# AGENDA Special City Planning Committee Meeting Open Portion

Monday, 26 April 2021

### **MEMORANDUM: CITY PLANNING COMMITTEE**

### **APPLICATION UNDER HOBART INTERIM PLANNING SCHEME 2015**

Figure 9: South facing elevation of the proposed development, facing the boundary with 56 Hall Street.

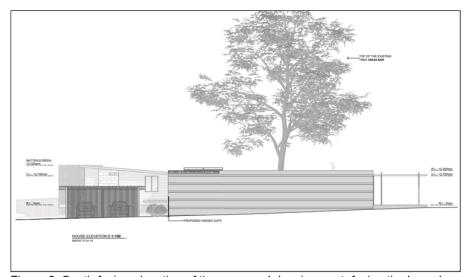
-The main problem with this development is the increase in the size of the proposed building right across the allotment, and the increased visual impact this will have - especially from Ridgeway Road - and the reduction in boundary setback on the southern side. The proposed southern boundary setback of this development to only a little over 3 metres means that the proposed dwelling will effectively fill the whole of the allotment, and this is not in keeping with the objectives of the planning scheme. The existing dwelling is set back a long way from the southern boundary, so there will be a loss of the openness that the planning scheme states is characteristic of a rural area like Ridgeway;

very close to the boundary. The reduced setback of the proposed development at 19 Ridgeway Road from the southern boundary raises concerns regarding the impact of the development on the Tree Protection Zone of these trees. No arborist's report has been sought by Council. It is requested that the proposal clarify the impacts of the proposed development on these trees, which currently provide amenity, screening and

The proposed development has been designed in response to the topography of the site. The roof height has been kept to a minimum of 3.2 m from the existing cottages floor level. Given the block slopes gently to the front, it is slightly higher at the western end of the extension to maintain the existing floor level and to minimise the amount of excavation on site.

#### SITE PLAN 1:200

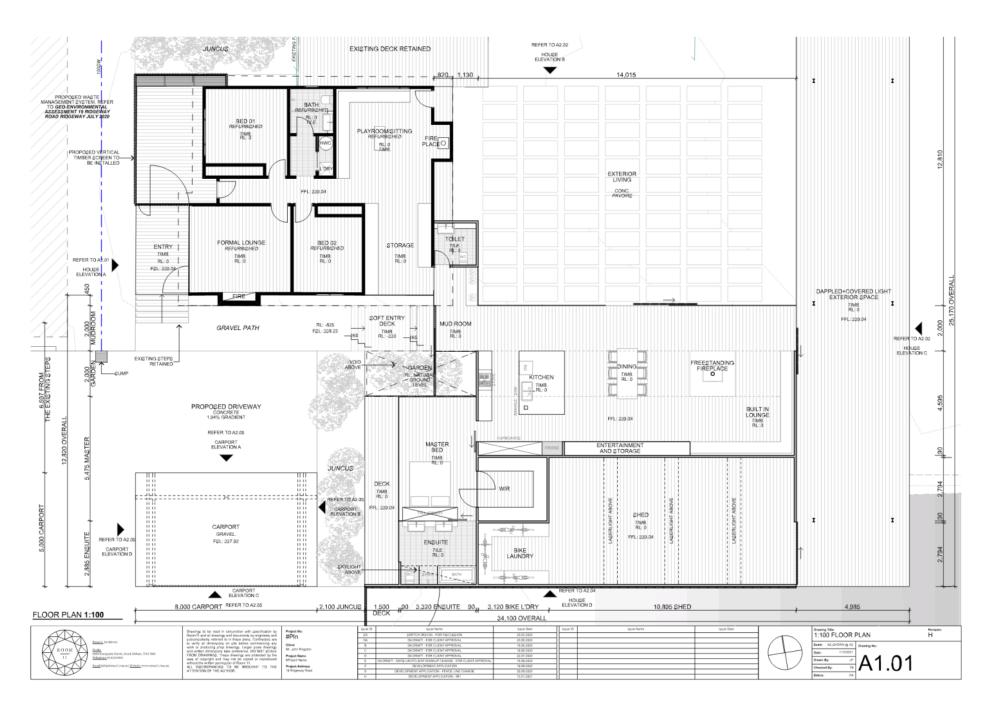
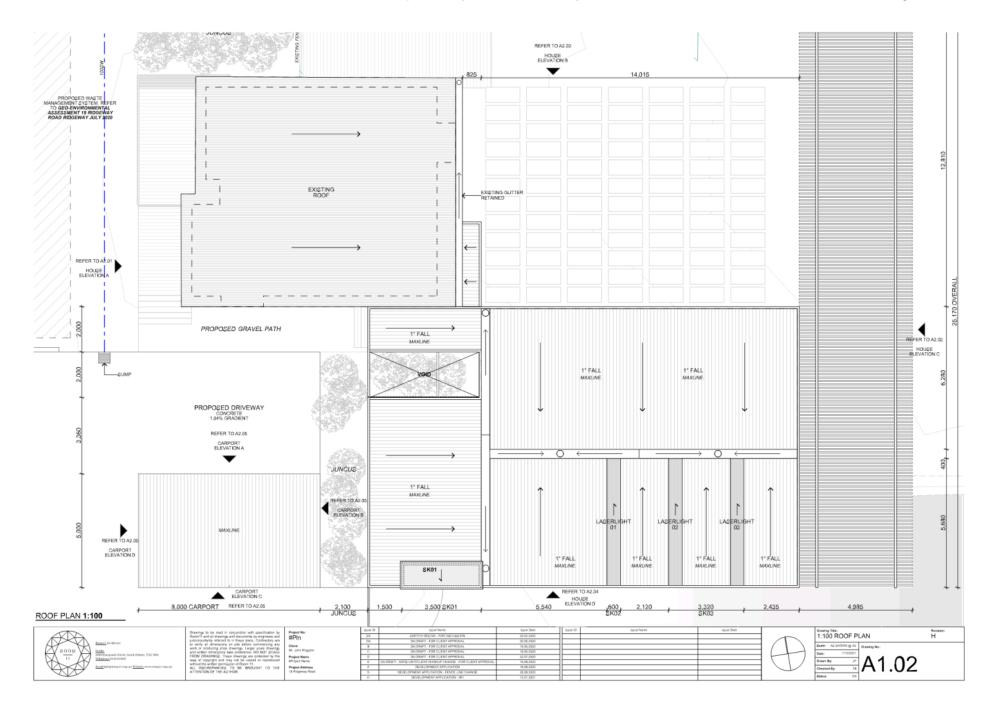
The proposed carport is set back from the southern boundary of the property at the min 3.115m (see 1:200 Site Plan A0.04). The proposed additions are in alignment with the orientation of the existing house, which is not parallel to the southern boundary. As such, the proposed addition is setback from the southern boundary min 3.38m, and max 3.88m.

Image 1: Aerial view of trees on adjoining property that may be impacted by the development

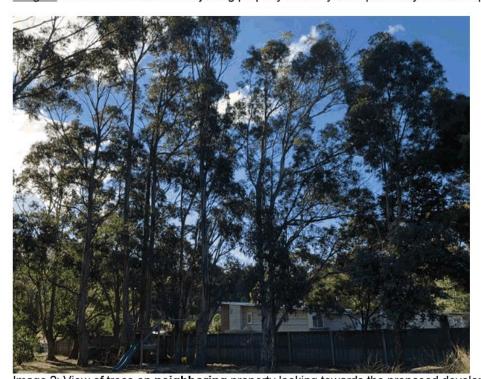
The Code applies because development is proposed that is likely to lead to the death of native vegetation within a Biodiversity Protection Area. There are twelve native trees on the adjacent property to the south that are close to the footprint of the proposed development (refer to Image 1 below).

Figure 1: Structural root zones relative to the proposed development

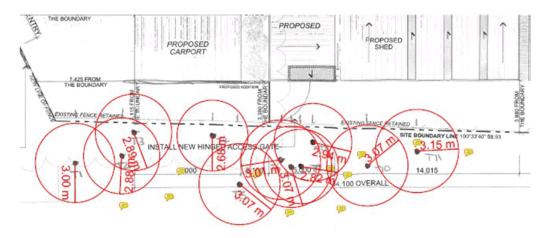
As can be seen in Figure 1, the proposed concrete driveway would encroach upon the SRZs of trees 3 and 4, and as can be seen in Figure 2, the development would encroach upon all of the tree's TPZs.

A further AS4970 assessment was carried out to determine the likely impact to the trees in the absence of the proposed concrete driveway south of the proposed car port. The results are presented in Table 2 below and show that this small change would result in:
